## **Customer Service Bulletin SD800006 Cable Issues in SE125 IP66 Transmitters**

**Application:** This bulletin applies to **SE125 IP66 Transmitters SLF33300/01 or SLF33400/01/02**. This applies to SE transmitters shipped prior to February 15, 2013.

Example #1 - 9C012042 cable, SE125 IP66 Single and Dual Transmitters:

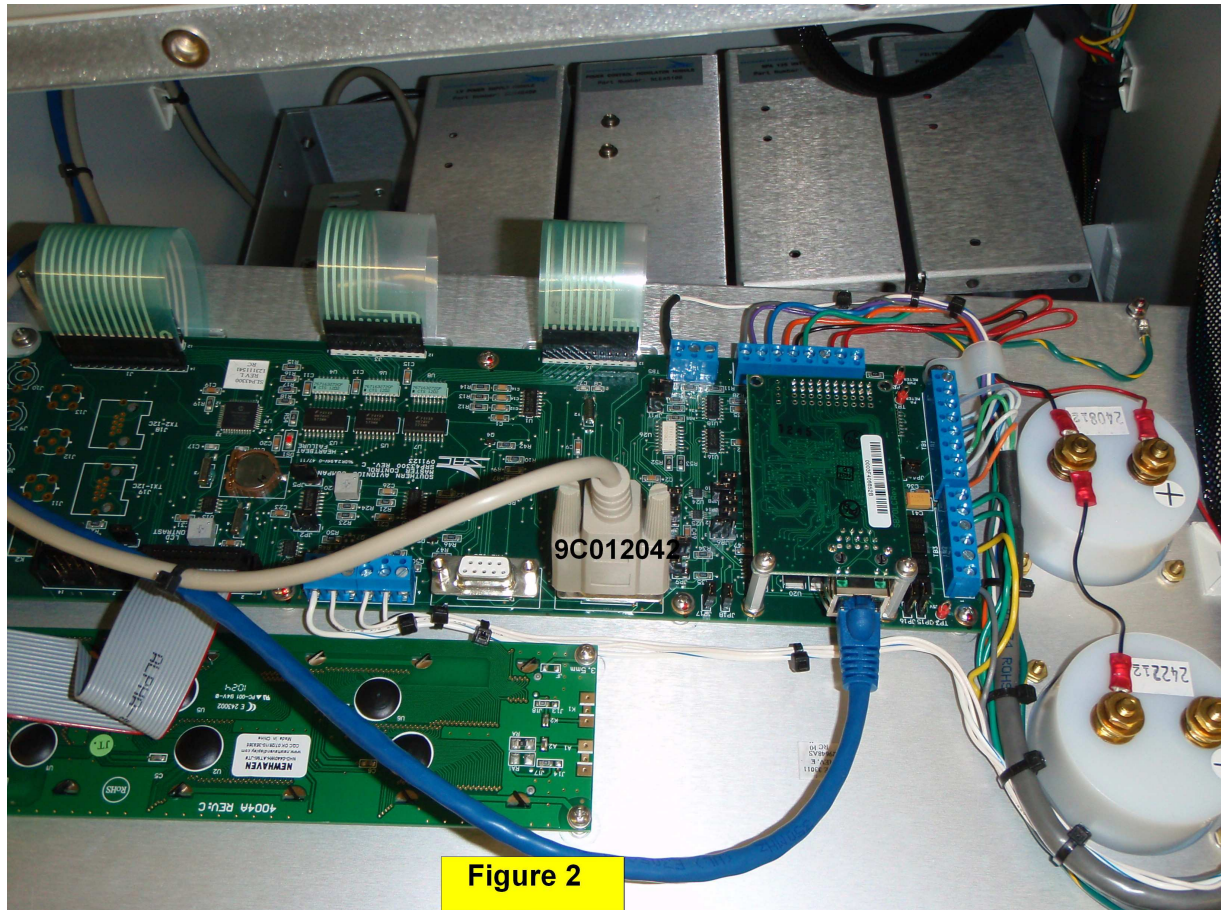
- Remove cable ties and disconnect the 9C012042 cable from the SLP45500 Transmitter Control PCB per Figure 1.
- Continue to Figure 2.

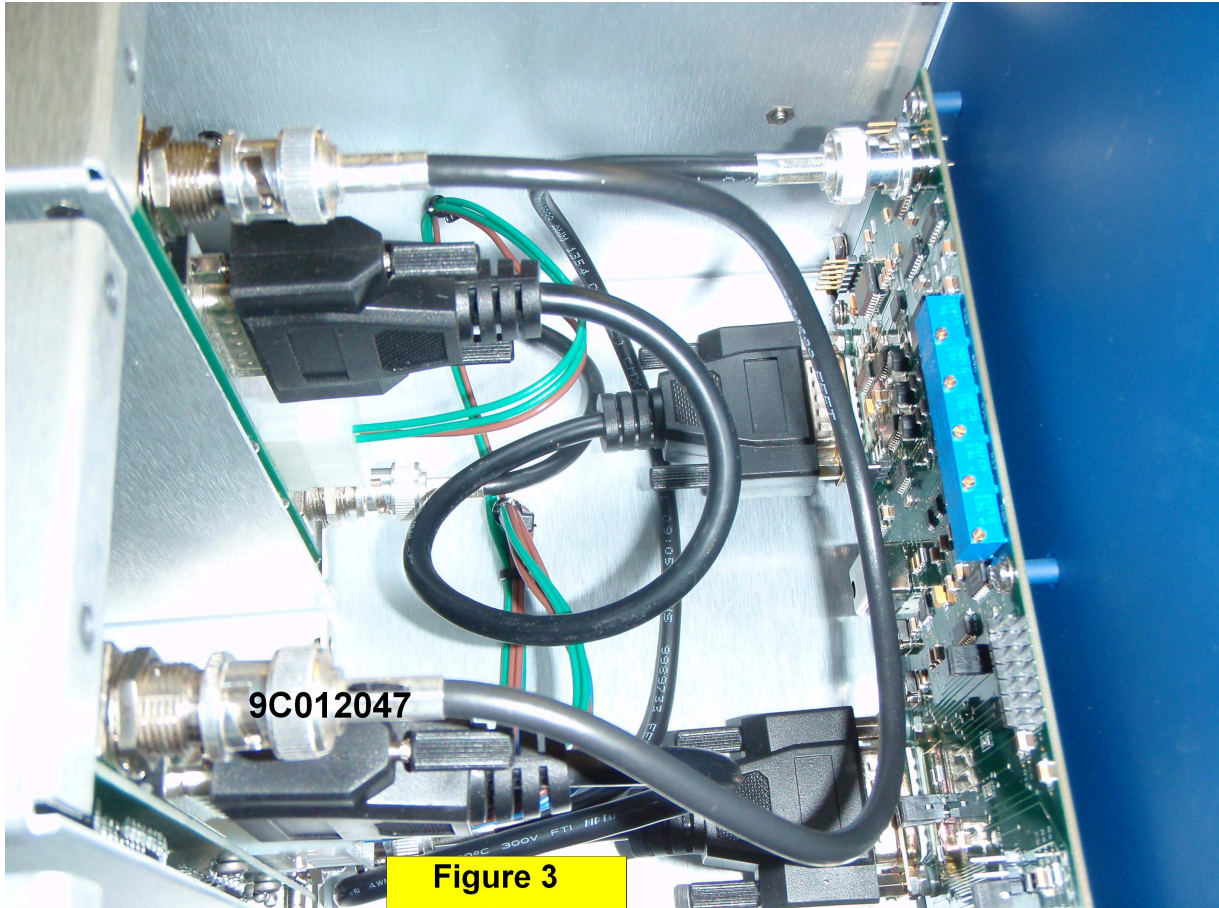
- Disconnect the other end of the 9C012042 cable from the SLP43300 Master Control PCB per Figure 2.
- Install replacement cable 9C012061 between the SLP43300 Master Control PCB and the SLP45500 Transmitter Control PCB and secure with new cable ties.
- Repeat for second transmitter drawer in SE125 IP66 Dual Transmitters.

Example #2 - 9C012047 cable, SE125 IP66 Single and Dual Transmitters:

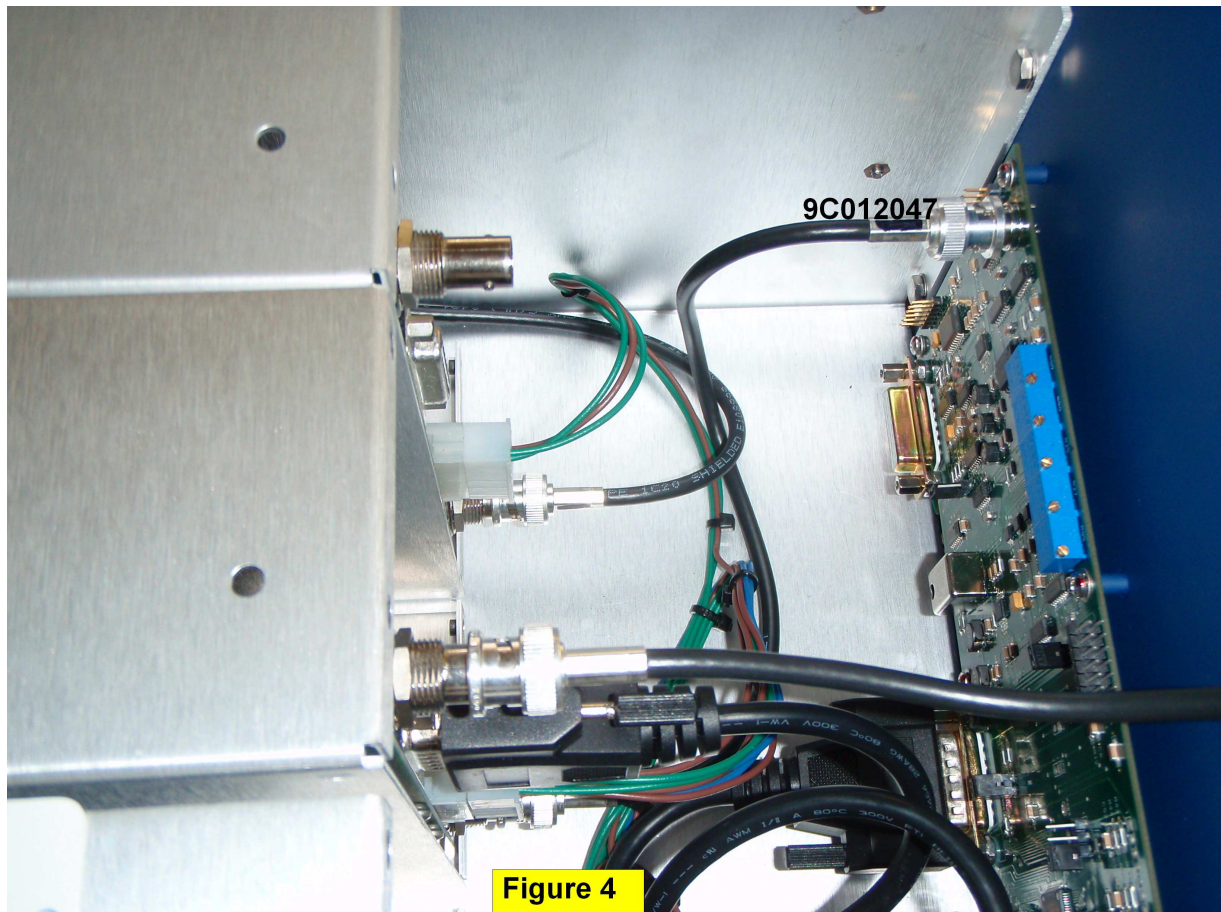
- Remove the 9C012047 cable between the SLE45000 SPA Module and the SLE45200 Filter Bridge Module per Figure 3.
- Repeat for second transmitter drawer in SE125 IP66 Dual Transmitters.

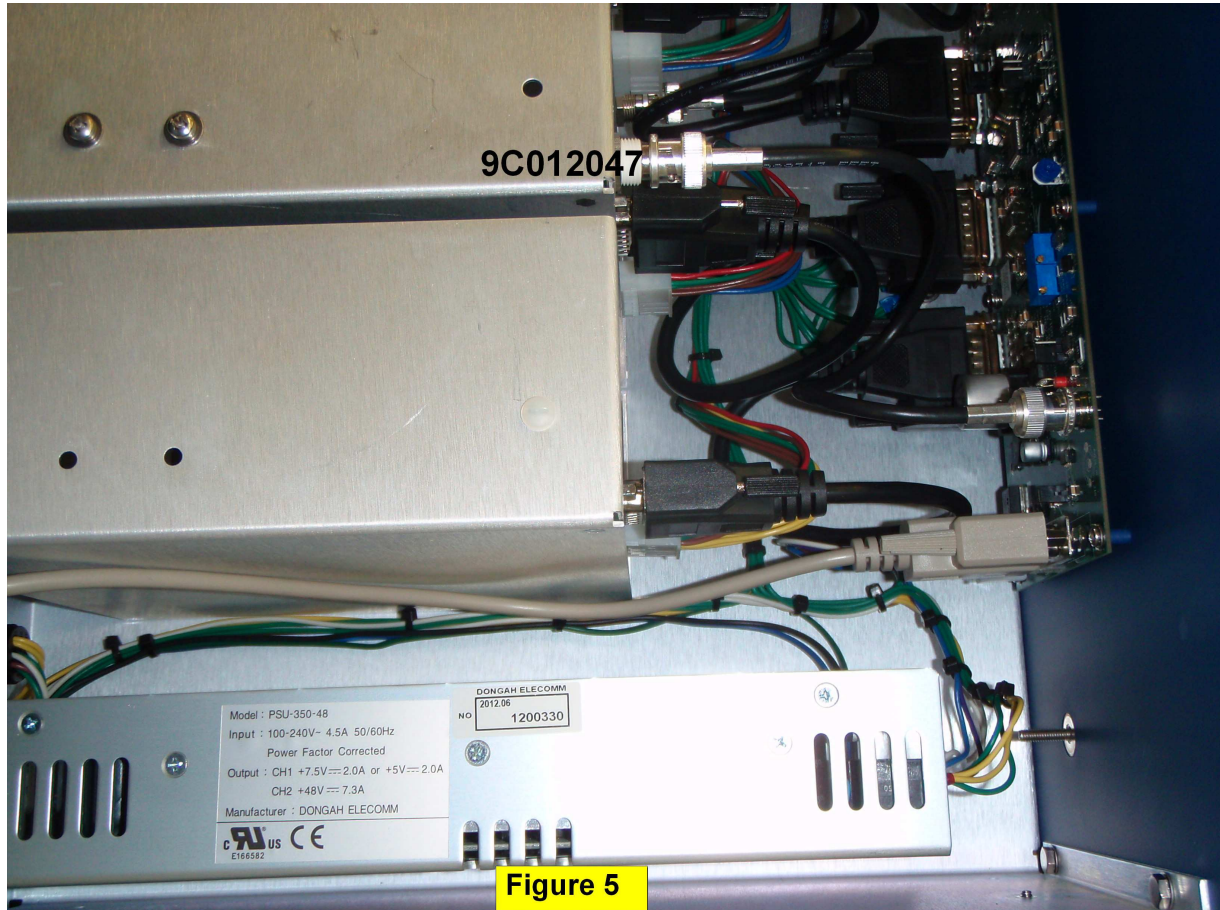
- Remove the 9C012047 cable between the SLE45000 SPA Module and the SLP45500 Transmitter Control PCB per Figure 4.
- Repeat for second transmitter drawer in SE125 IP66 Dual Transmitters.

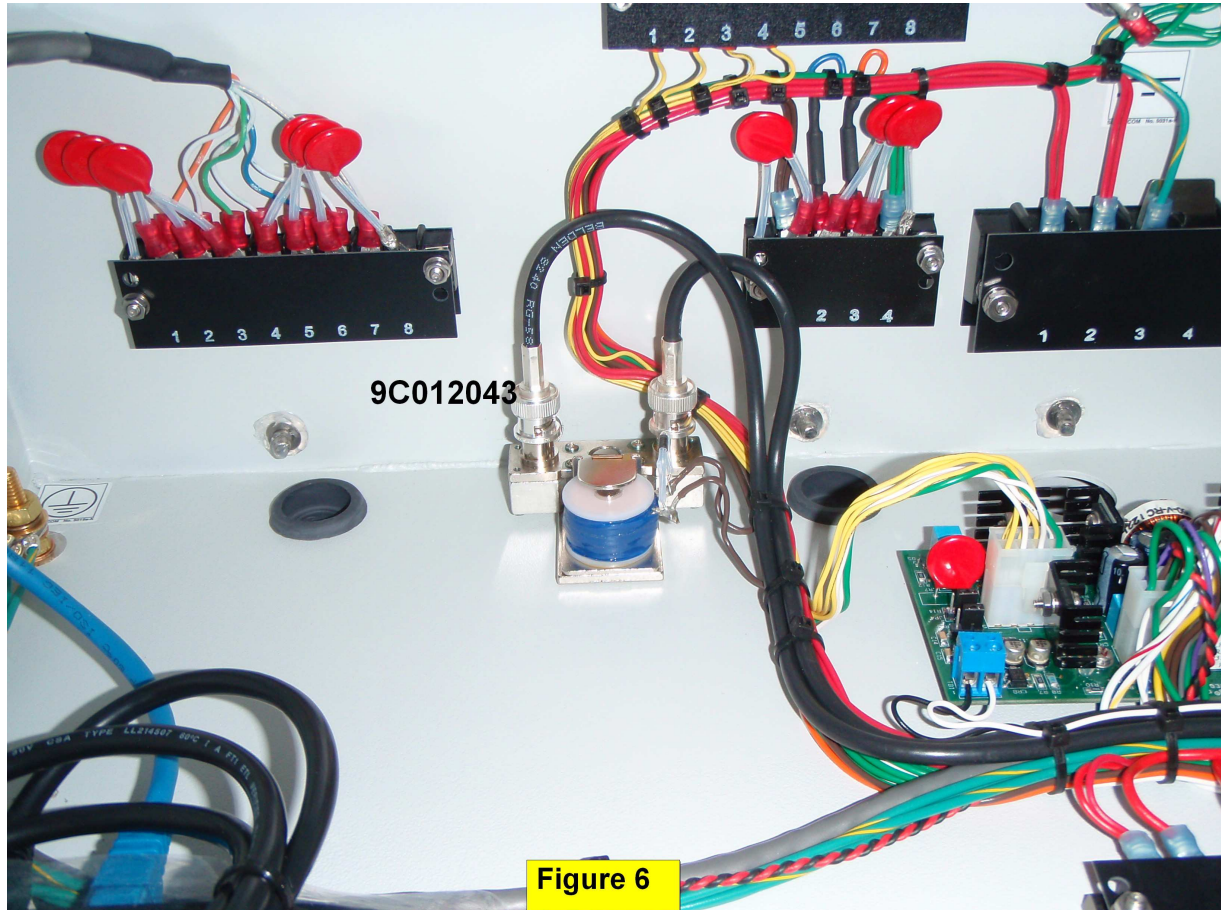
- Remove the 9C012047 cable between the SLE45100 Power Control Modulator Module and the SLP45500 Transmitter Control PCB per figure 5.
- Install replacement cable 9C012065 between the assemblies.
- Repeat for second transmitter drawer in SE125 IP66 Dual Transmitters.

Example #3 - 9C012043 cable, SE125 IP66 Dual Transmitters:

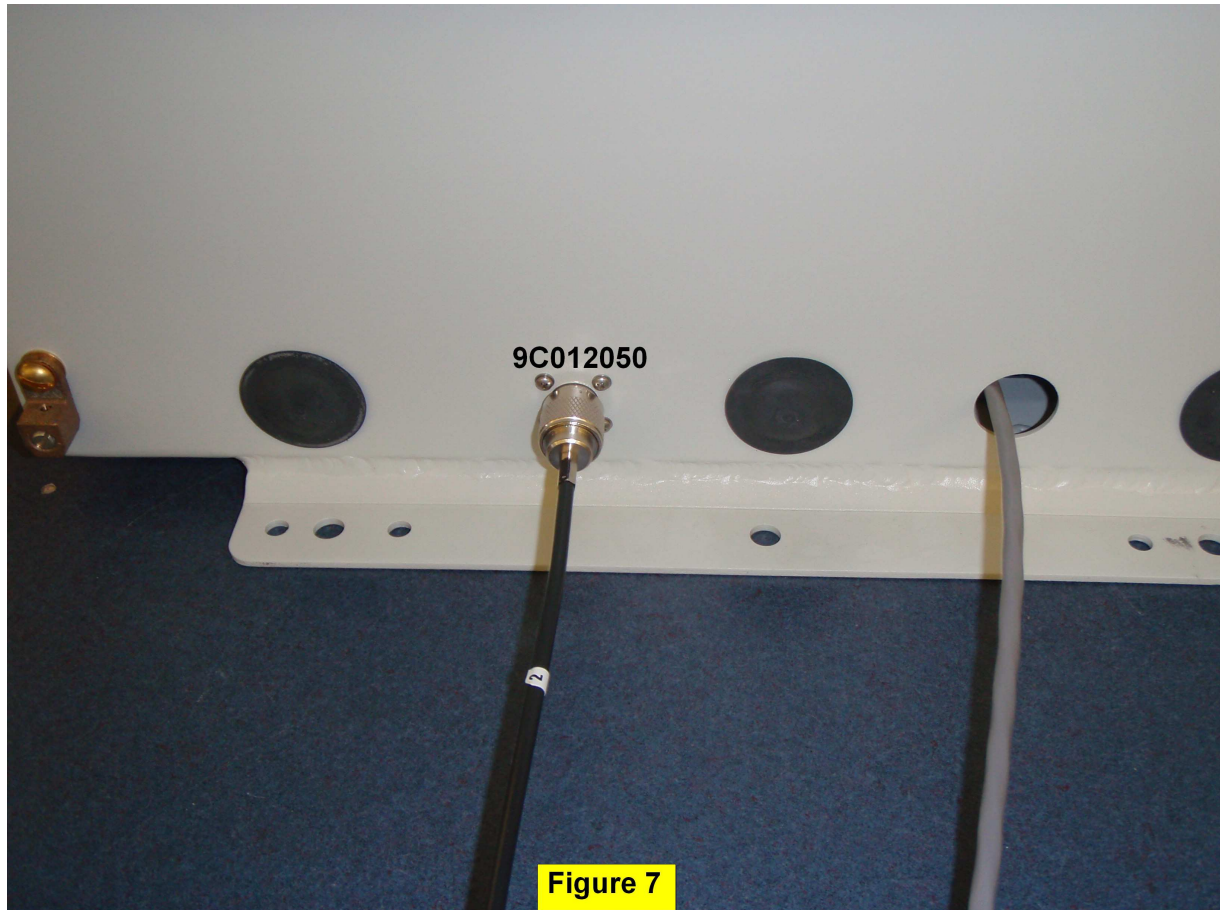
- Remove cable ties and disconnect the 9C012043 cable from coil K3, position 1 (left-hand cable) per Figure 6.
- Disconnect the other end of the 9C012043 cable from the SLE45200 Filter Bridge Module in Transmitter drawer 2 (4A1) for dual systems only.
- Install replacement cable 9C012064 between the SLE45200 Filter Bridge Module and coil K3, position 1, and secure with cable ties provided.
